Planning Commission Staff Report

Item 5.b.

- SUBJECT:** P16-0871
- APPLICANT:** Alan Page
- PROPERTY OWNERS:** Dave and Cindy Johnston
- PURPOSE:** Application for Design Review approval to construct an approximately 4,640-square-foot, one-story single-family residence with an approximately 933-square-foot attached garage on an approximately 3.76-acre parcel
- LOCATION:** 7 Winding Oaks Drive (Lot 7)
- GENERAL PLAN:** Low Density Residential and Open Space-Public Health and Safety
- SPECIFIC PLAN:** Vineyard Avenue Corridor
- ZONING:** Planned Unit Development – Hillside Residential/Open Space (PUD-HR/OS) District
- EXHIBITS:**
- A. [Draft Conditions of Approval, dated May 25, 2016](#)
 - B. [Project plans, view simulations, and color and material board dated "Received April 15, 2016"](#)
 - C. [Location and noticing map](#)
-

Figure 4: Proposed Elevations

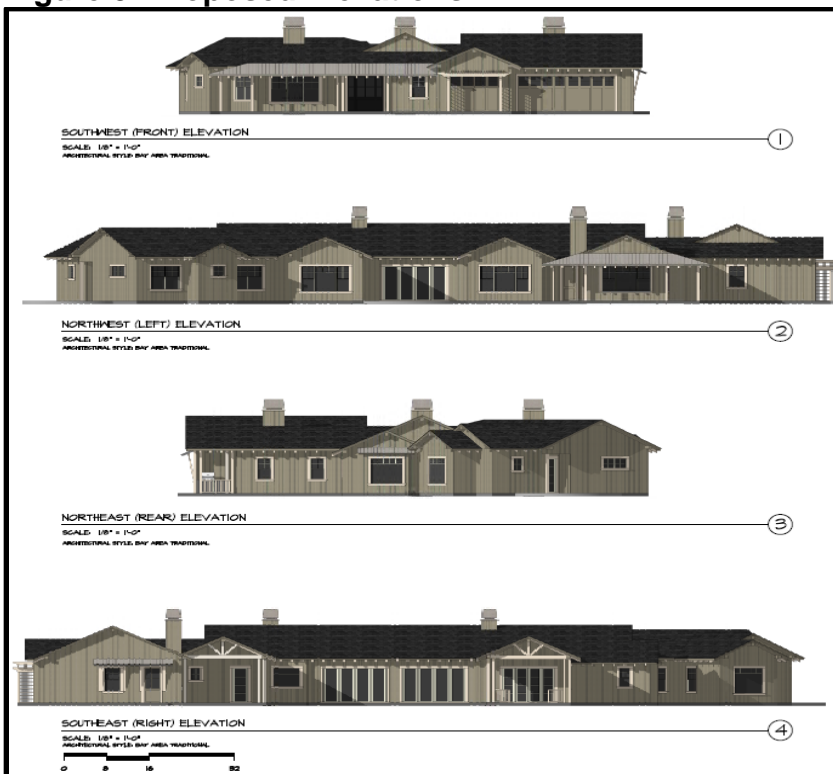
The proposed home is a one-story structure with articulated wall lines and variable roof lines that reduce the perceived massing of the home and promote visual interest. The entire residence incorporates wood clapboard cladding and dark composition shingle roofing (except for metal roofing over the front entry porch), consistent with the intended architectural style. The main body color is a medium tan or beige, consistent with the recommended earthtone color range for the subdivision.

As proposed, the exterior walls of the house will be articulated and the detailing of the building will be compatible with others in the neighborhood. The use of wood clapboard treatments, wall articulation and detailing will create an attractive home for the neighborhood. The prominent wraparound front entry porch element with the metal roof adds architectural interest and the home design incorporates high quality materials and elements. The front entry and garage doors are sufficiently detailed and are compatible with the design of the proposed home. The architectural design and finish materials/colors are generally consistent in their interpretation of the required Craftsman/Bay Area Traditional architectural style. Figures 4 and 5 show the proposed elevations.
